AMENDMENT OF DRAWINGS

FIG.7

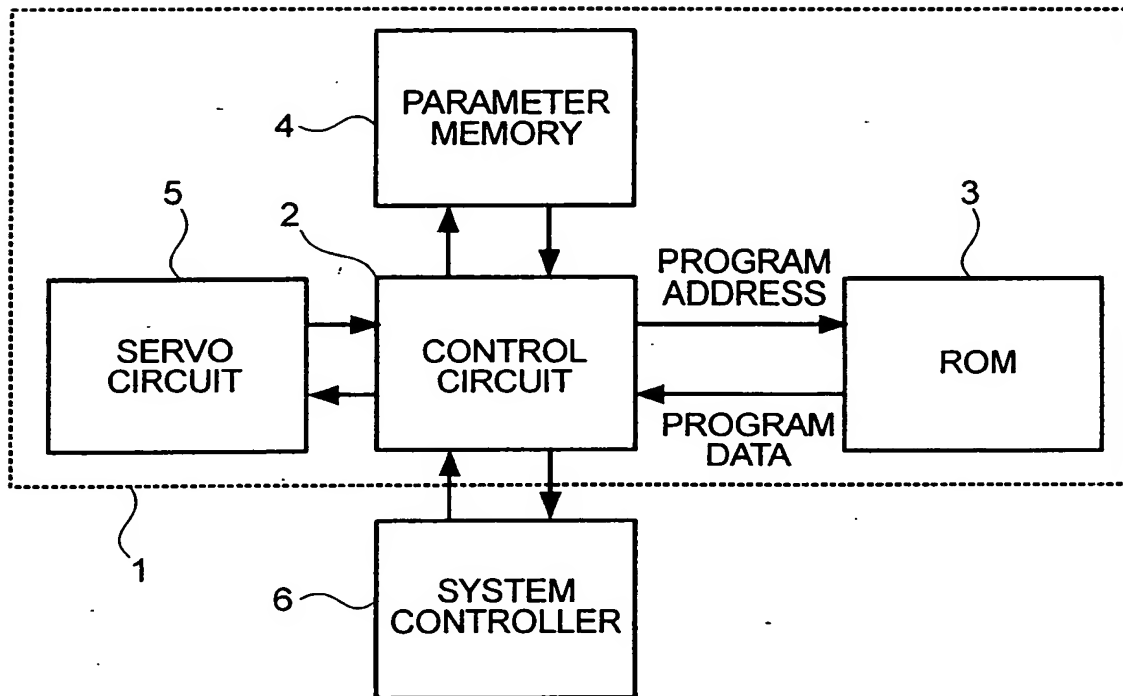
Please replace Figs. 2 and 7 with the attached replacement drawings. Fig. 1 is amended to add a --Prior Art—legend. In Fig. 7, descriptions for items 10-13 and 23 are added. Specifically, item 10 is denoted as optical disc, item 11 is denoted as spindle motor, item 12 is denoted as object lens, item 13 is denoted as optical pickup, and item 23 is denoted as driver circuit.
